Docket No. LC 77

In the Matter of ·  
PACIFICORP, dba PACIFIC POWER,  
2021 Integrated Resource Plan.

Opening Comments of  
NW Energy Coalition

**Figure 9.37 – 2021 IRP Preferred Portfolio Energy Efficiency (Class 2 DSM) and Direct Load Control Capacity (Class 1 DSM)**

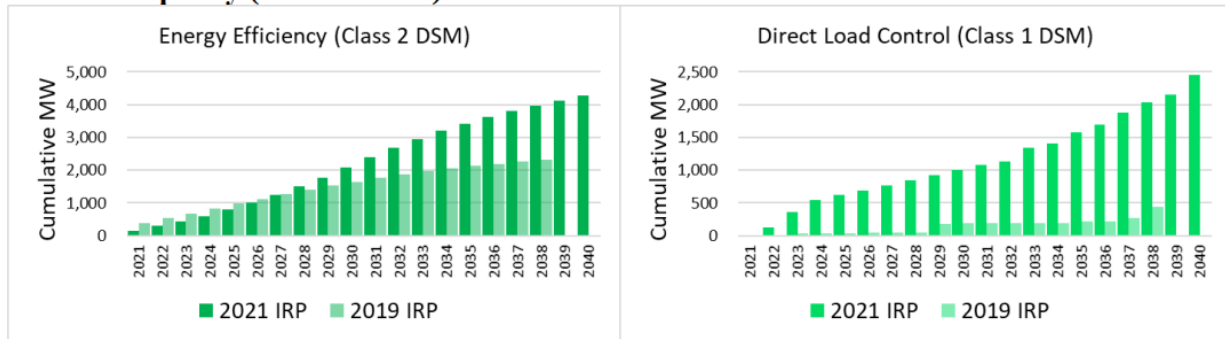
The energy efficiency (Class 2 DSM) effort continues to progress, and as shown in Figure 9.37, indicates a substantial upswing continuing after the mid-2020s, in comparison to previous IRPs where energy efficiency tended to decline year-over-year after that point.

The rapid uptake of demand response, also called direct load control (Class 1 DSM) to distinguish that from rate-design induced demand response (Class 3 DSM, price response and load shifting), is a major new development, after many years of low ambition and long lead times. The Preferred Portfolio anticipates 549 MW of new DR by 2024 – a level achieved only in the late 2030s in the 2019 IRP.

We applaud this recognition at last of DR potential, while noting that achieving this ambitious early target will require considerable effort by the Company and effective coordination with customers and suppliers. The anticipated value of DR for balancing and reliability in a cost-

**Figure 1.4 – 2021 IRP Preferred Portfolio New Solar Capacity\***

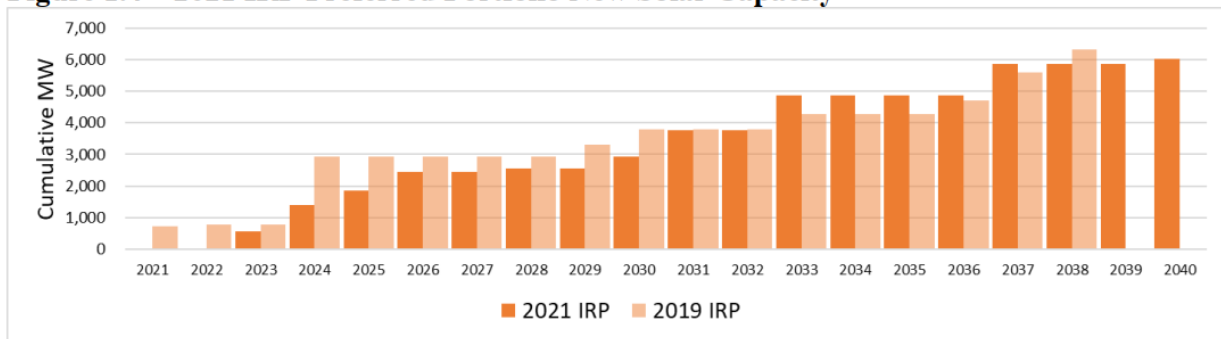
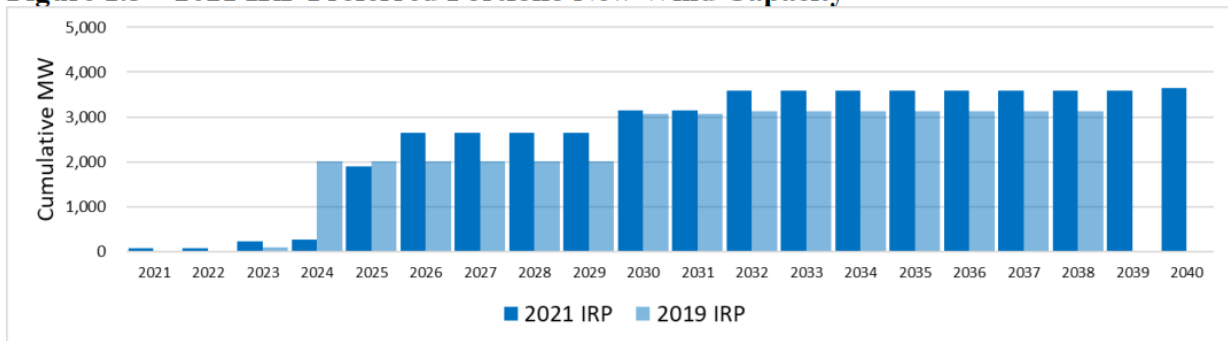
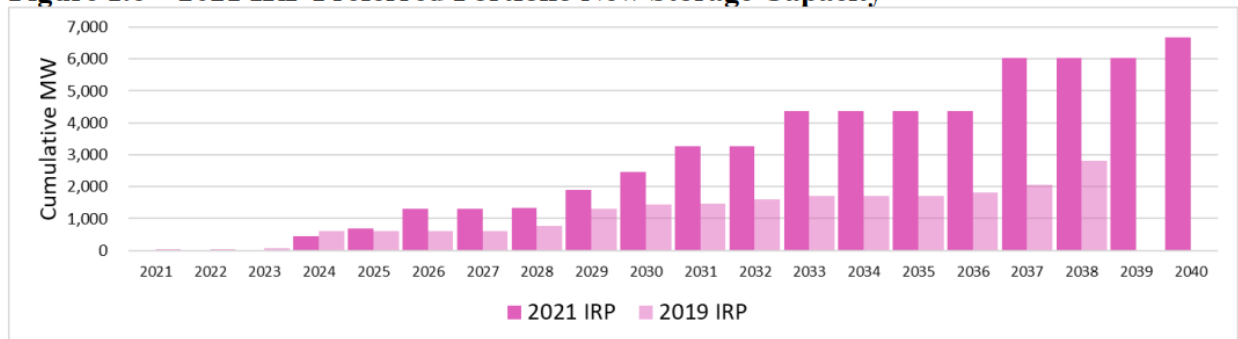
NWEC is also heartened by the continued expansion of renewable and storage resources in the 2021 IRP, as shown in Figures 1.4, 1.5 and 1.6.
